PROCESS CHANGE NOTICE
 PRODUCT CHANGE NOTICE

MAX2173 (WG73) Final Test Transfer to Sigurd on UltraFlex Qual Results

Figure 1: Example of LDO contact test delta between Sigurd and original data. Non-issue as this is caused by intentional test improvement.

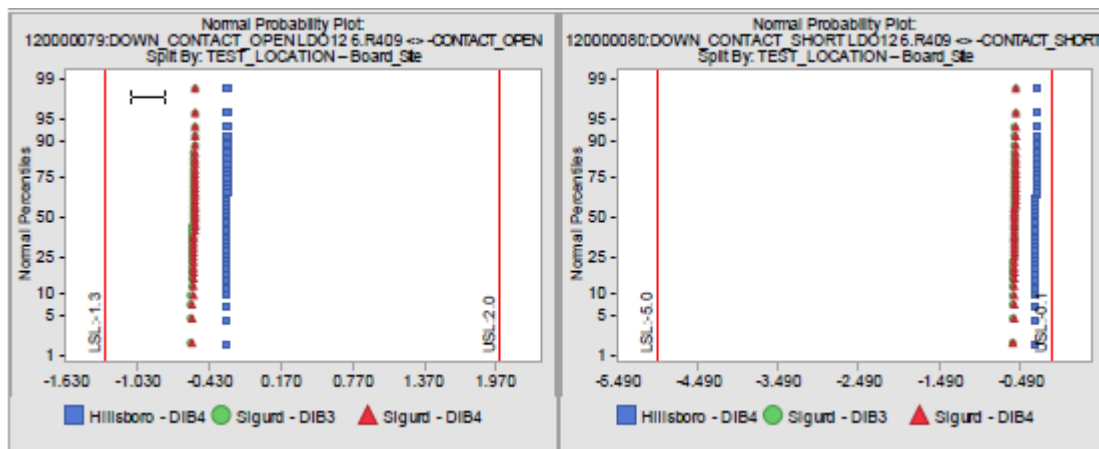
40 KGU was generated at the test development site and shipped to Sigurd for initial correlation using the FT_ROOM flow. Results of KGU testing in Sigurd matched well to the original data set except for a few LDO contact tests (see Figure 1). Upon review by our TE, the contact test in question was intentionally modified after the initial data collection of the KGU by adding additional delay in order to match the results on the UltraFlex to that of the existing production platform. Hence, this delta was expected and is a non-issue.
